PETITION TO AMEND INTERIM	)	Case No.: CCH-MA13-01
INSTREAM FLOW STANDARDS FOR	)	
HONOPOU, HUELO (PUOLUA),	)	OBJECTIONS, IN PART, OF
HANEHOI, WAIKAMOI, ALO,	)	MAUI TOMORROW TO
WAHINEPEE, PUOHOKAMOA,	)	HEARINGS OFFICER'S
HAIPIUAENA, PUNALAU/KOLEA,	)	AMENDED RECOMMENDATION
HONOMANU, NUAAILUA, PIINAAU,	)	RE INTERIM RESTORATION OF
PALAUHULU, 'OHI'A (WAIANU),	)	STREAM FLOW; EXHIBIT "A";
WAIOKAMILO, KUALANI,	)	MT EXHIBITS "1" – "40"; MT
WAILUANUI, WEST WAILUAIKI, EAST	)	MAPS "1" – "4"; CERTIFICATE
WAILUAIKI, KOPILIULA, PUAKEA,	)	OF SERVICE
WAIOHUE, PAAKEA, WAIAAKA,	)	
KAPAUULA, HANAWI and MAKAPIPI	)	
STREAMS	)	
	)

**OBJECTIONS, IN PART, OF MAUI TOMORROW TO HEARINGS OFFICER'S  
 AMENDED RECOMMENDATION RE INTERIM RESTORATION OF STREAM  
 FLOW**

**EXHIBIT "A"**  
**AMENDED CHART**  
**HANEHOI WATERSHED**

## Lowrie Ditch Diversion- W. Hanehoi Stream (L-6) intake 242.6

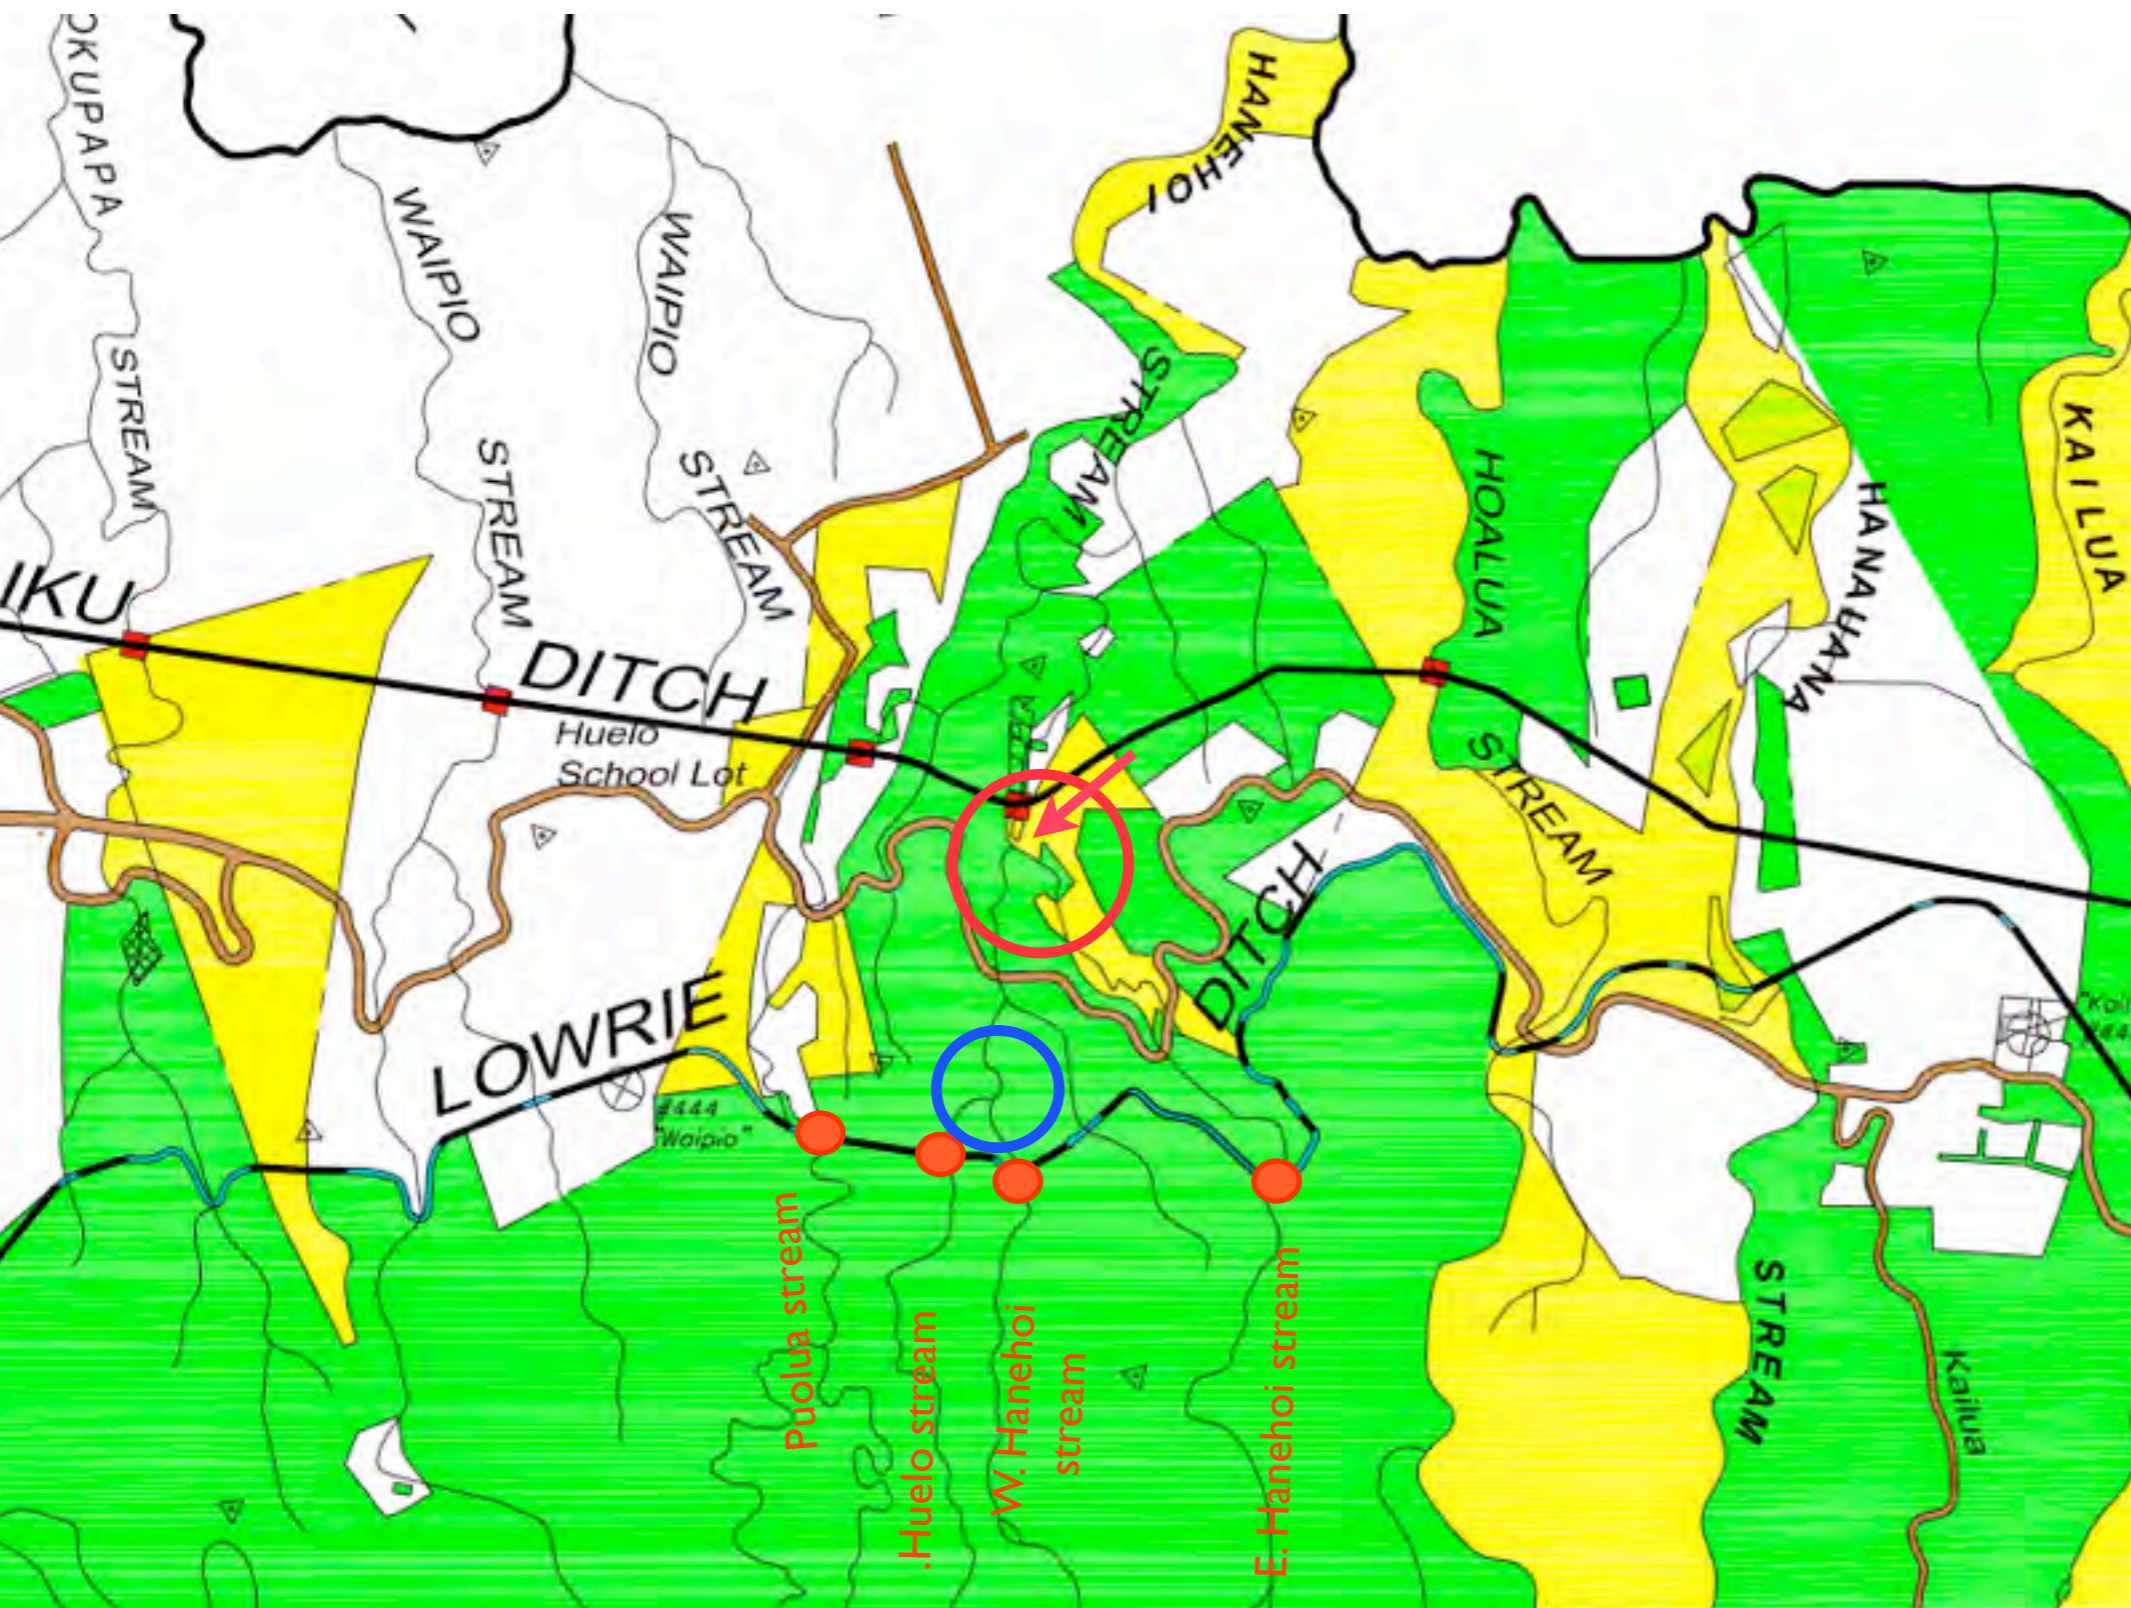
Closeup of Diversion  
structure  
L-6/ 242.6 on West  
Hanehoi stream  
channel.

Grate structure carries  
water to ditch. View is  
downstream of  
diversion intake. Not  
discussed in A&B's plan  
for stream restoration of  
Hanehoi stream.

## Lowrie Ditch Diversion- Huelo Stream (L-7) intake 155.6

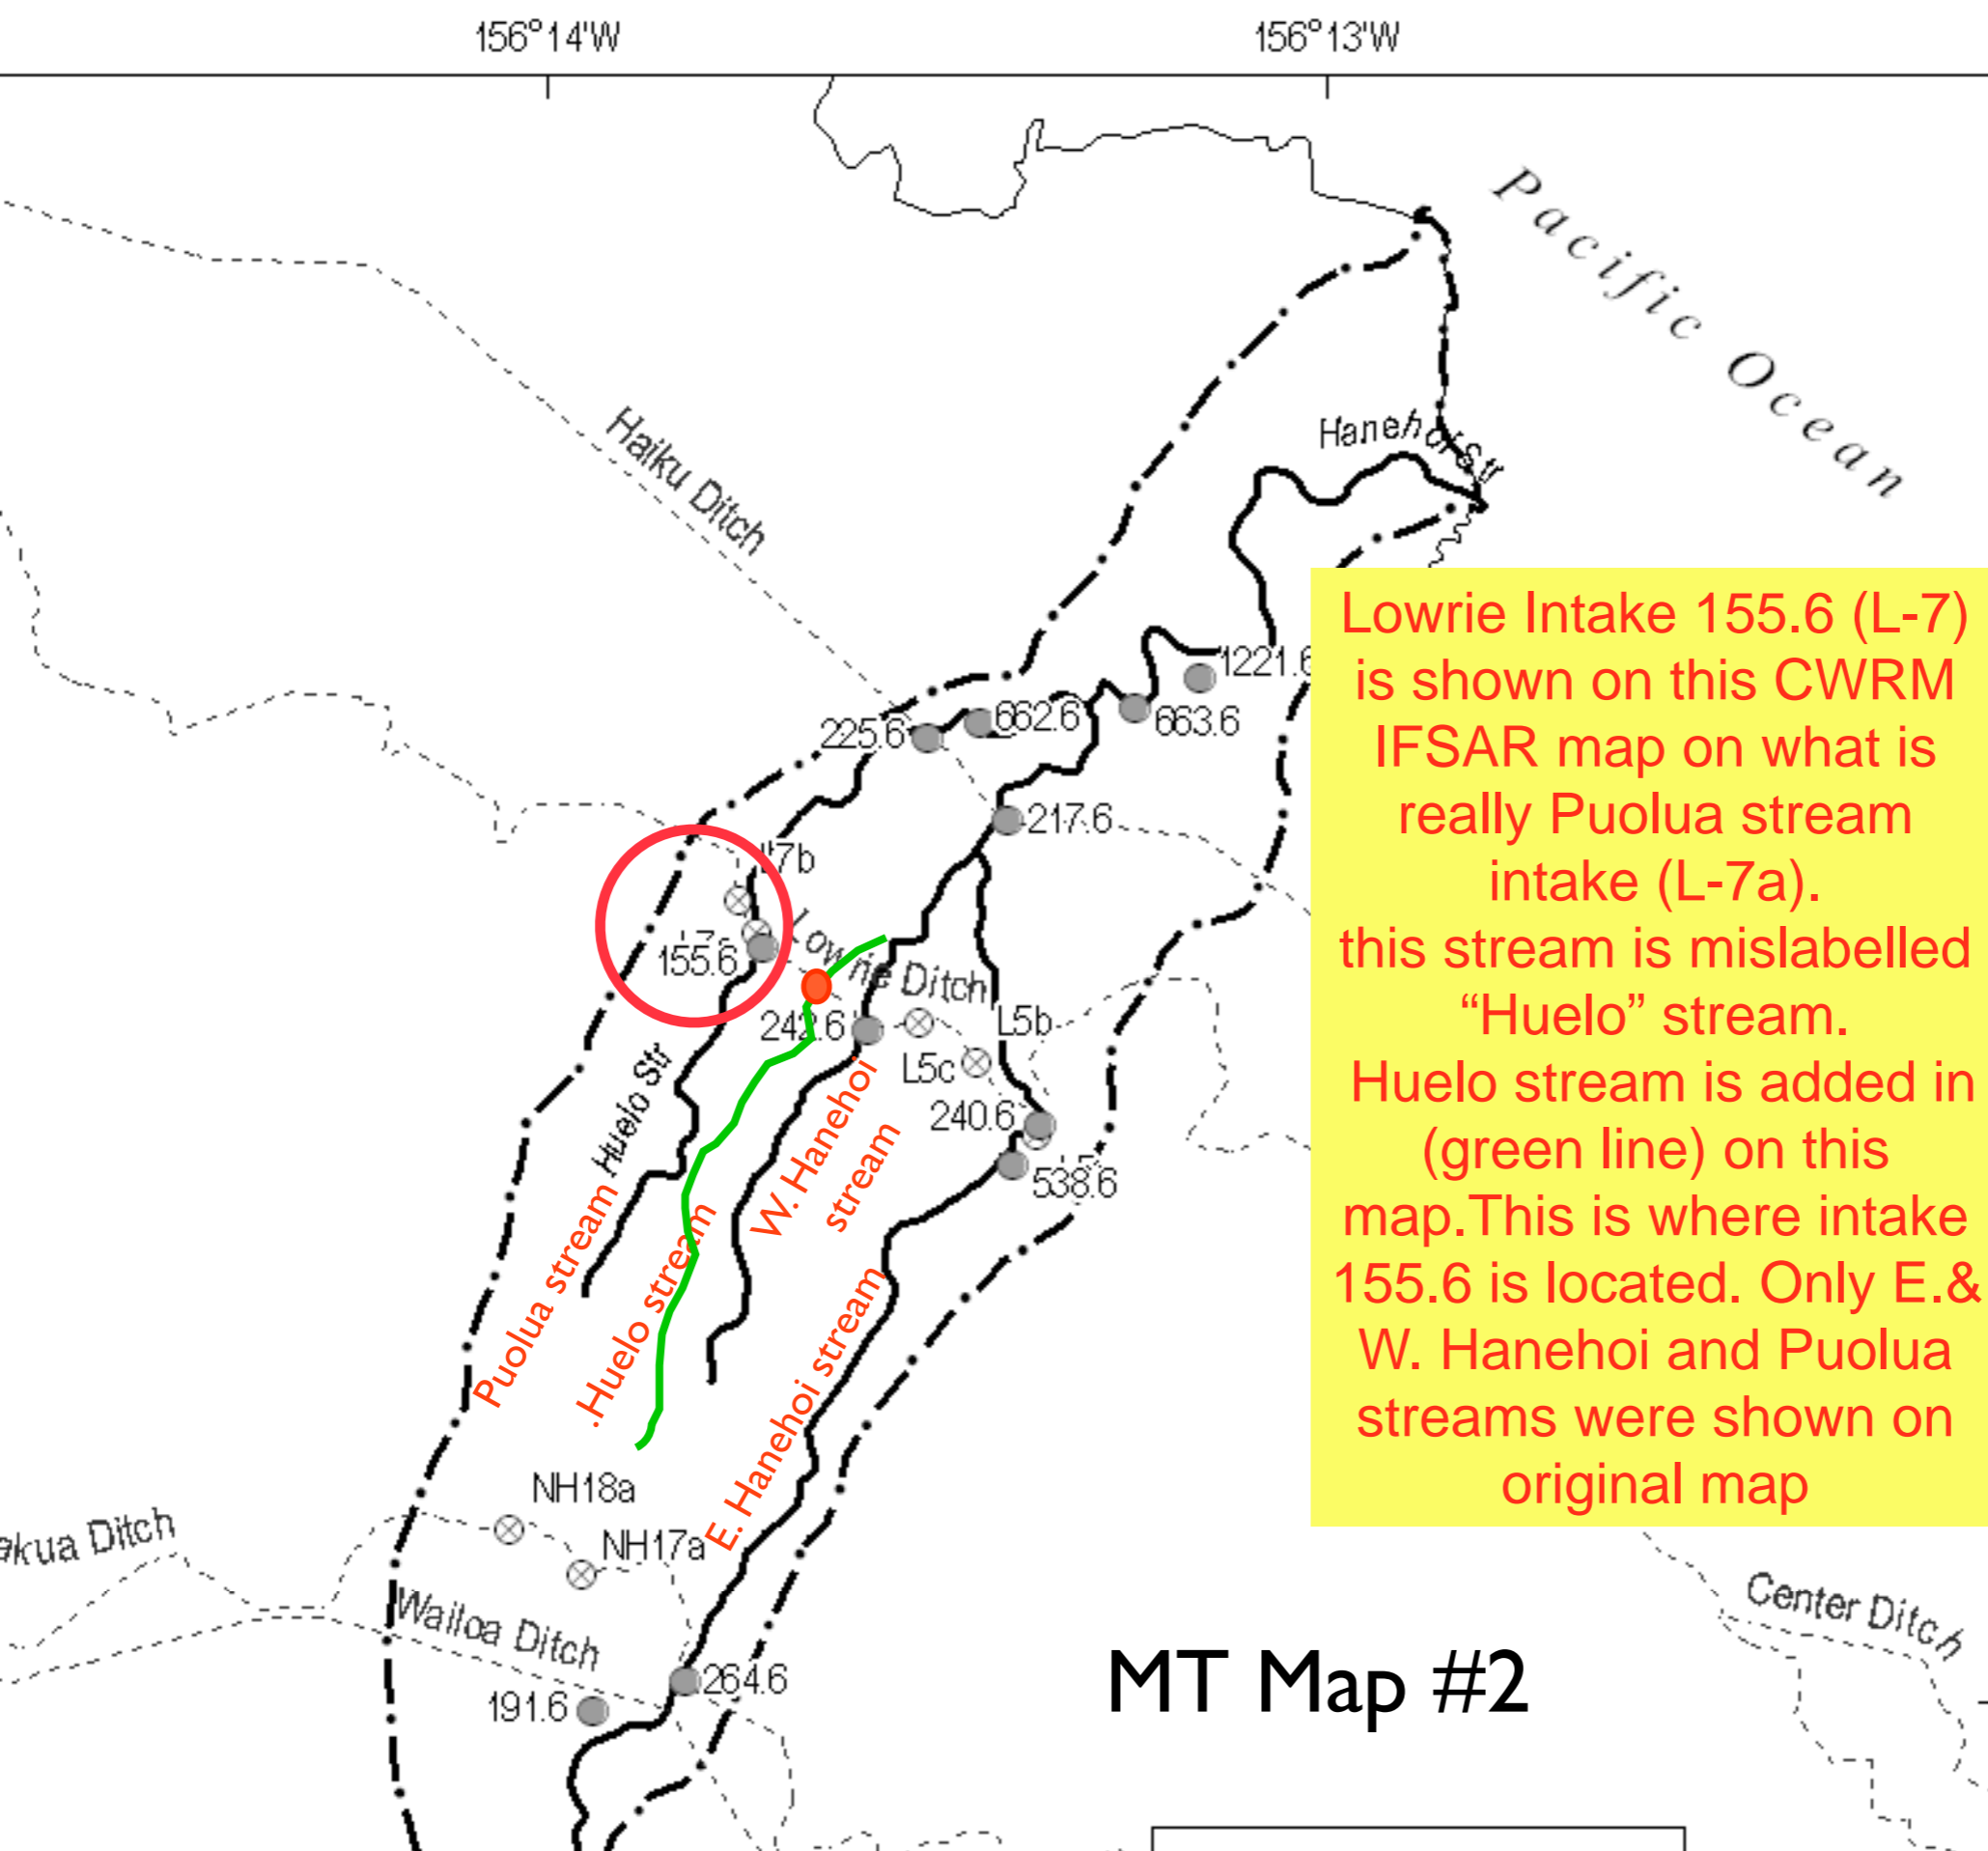
View of Lowrie ditch intake grate L-7/ 155.6 on Huelo stream channel.

This diversion is not discussed in A&B's first draft plan for stream restoration of Hanehoi stream, yet it appears the grate could be covered to allow flow.

**MT Map # 3**

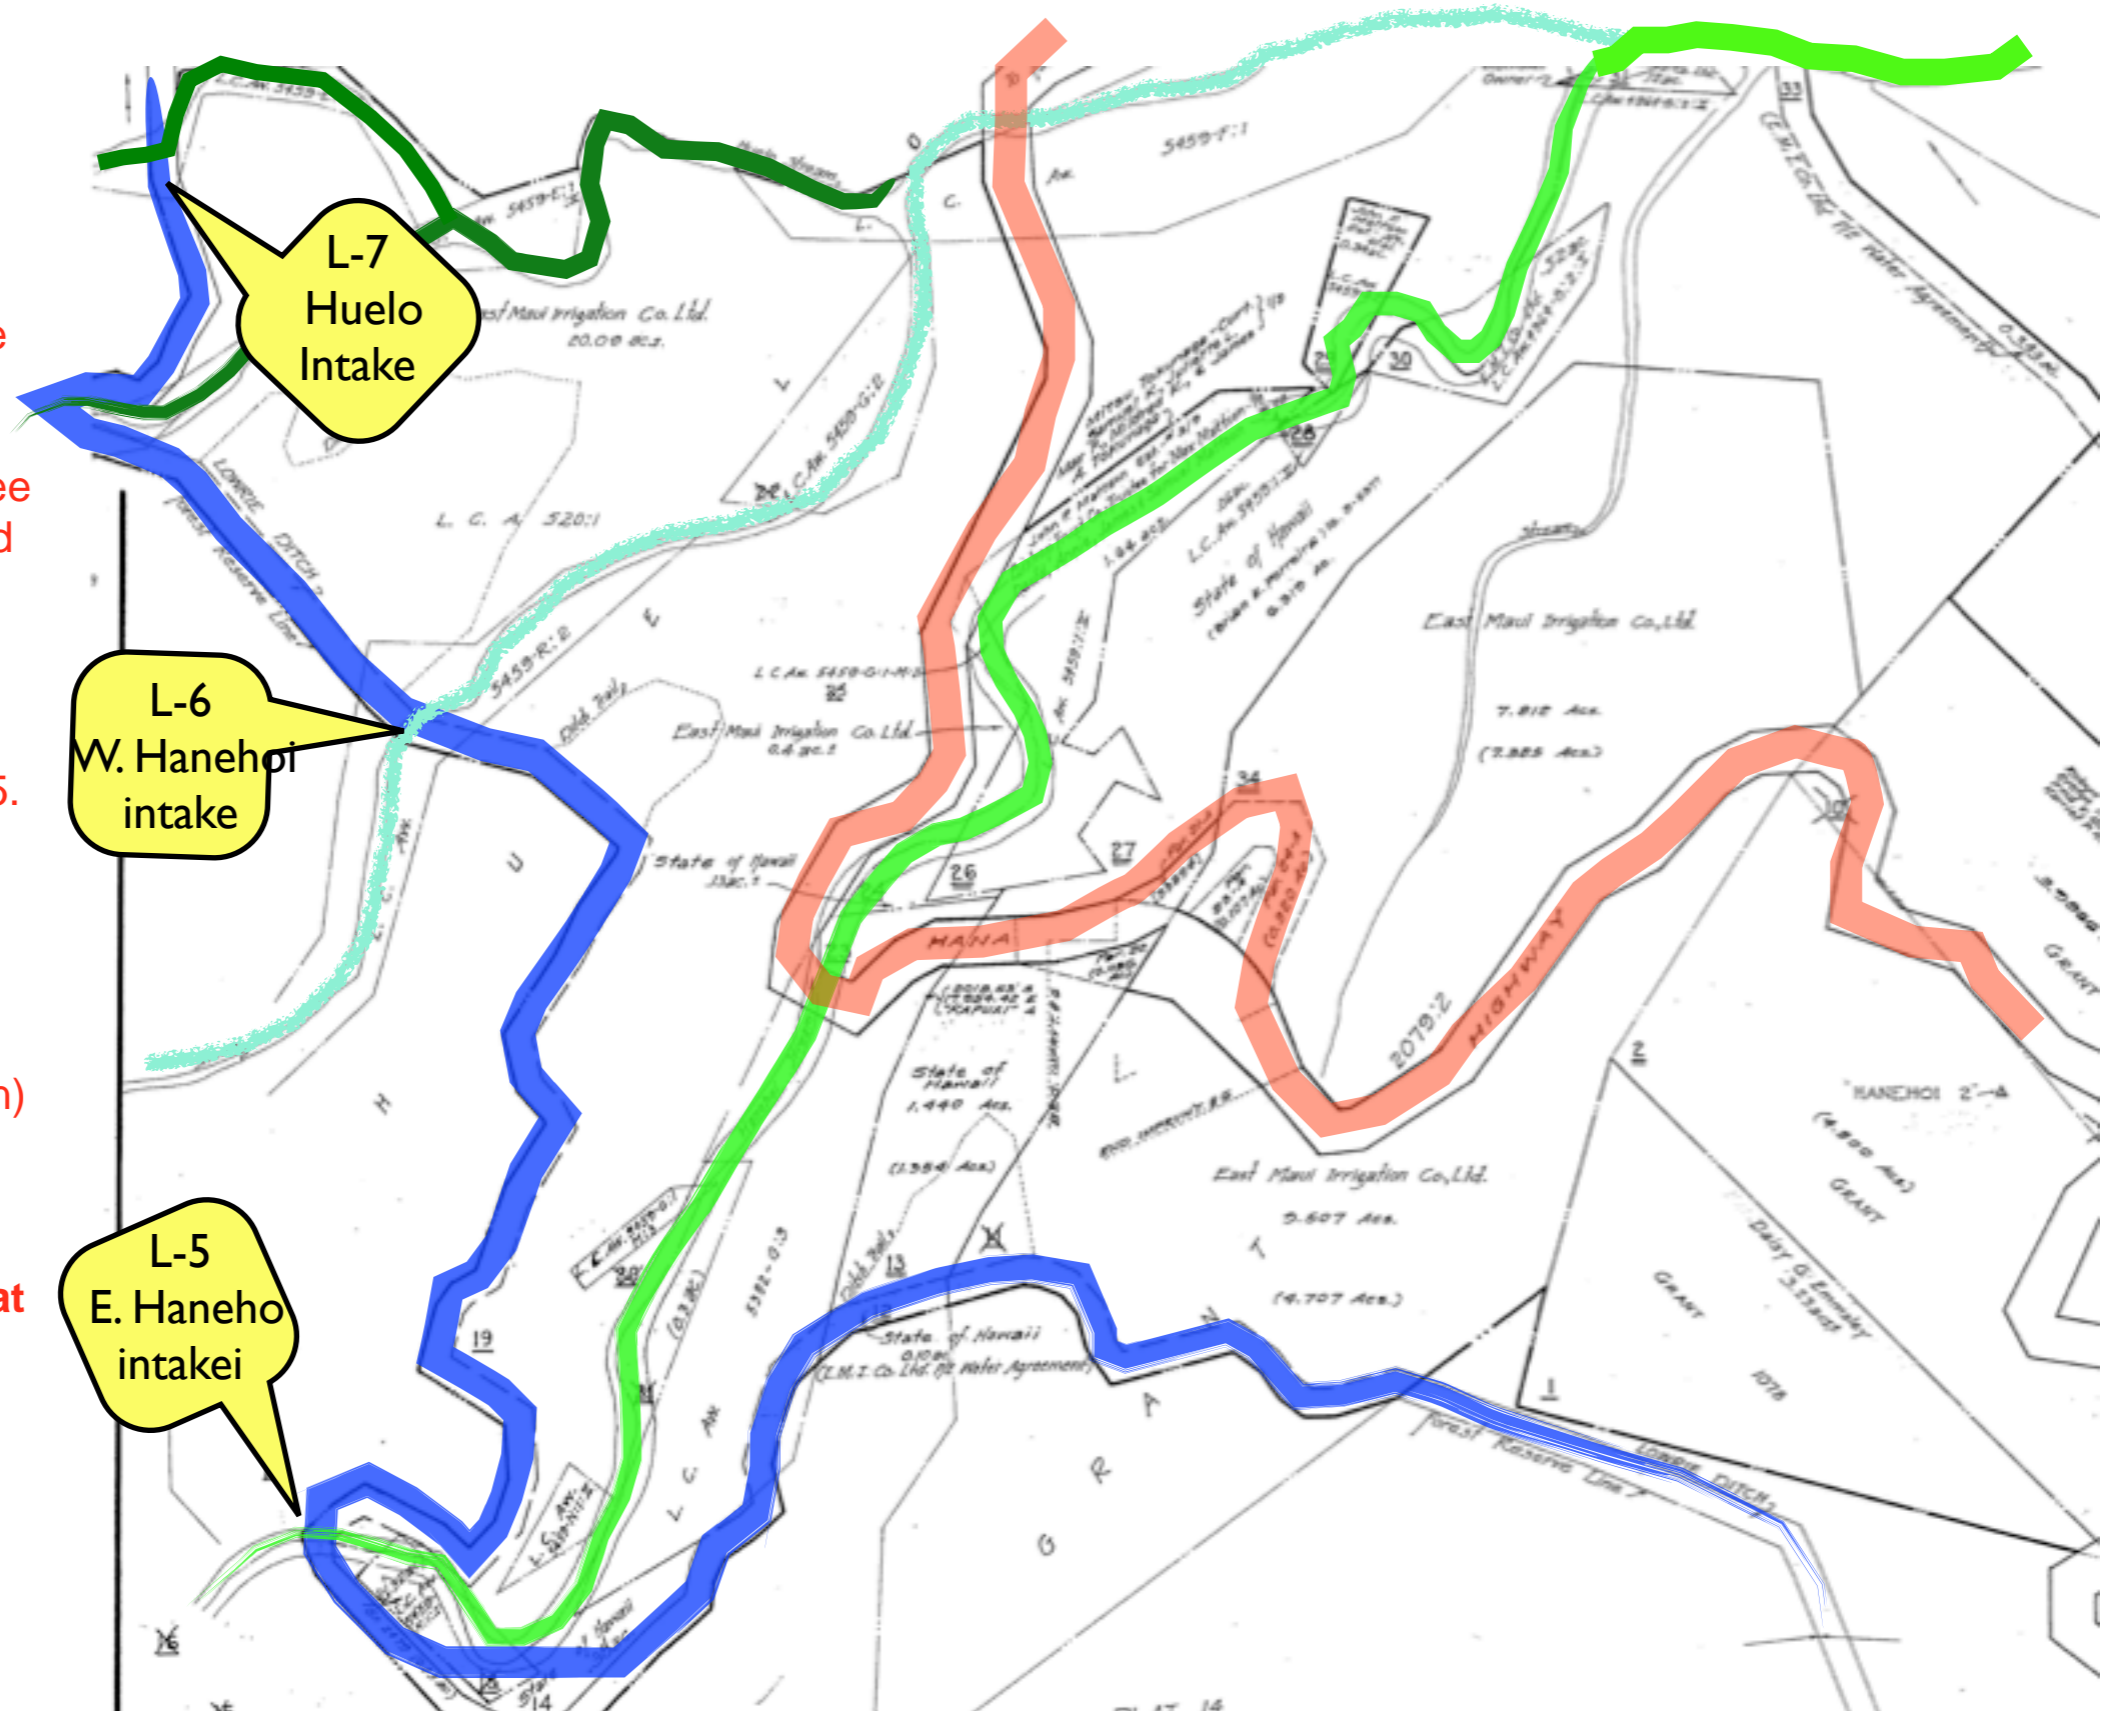
Clearly shows three  
streams crossing Lowrie  
ditch

East Hanehoi stream  
(brite green) crosses  
Lowrie ditch at intake L-5.

West Hanehoi stream  
crosses Lowrie ditch at  
intake L-6.

Huelo stream (dark green)  
crosses Lowrie Ditch at  
intake L-7.

**Puolua stream is on Plat  
map 06 so it does not  
show here.**
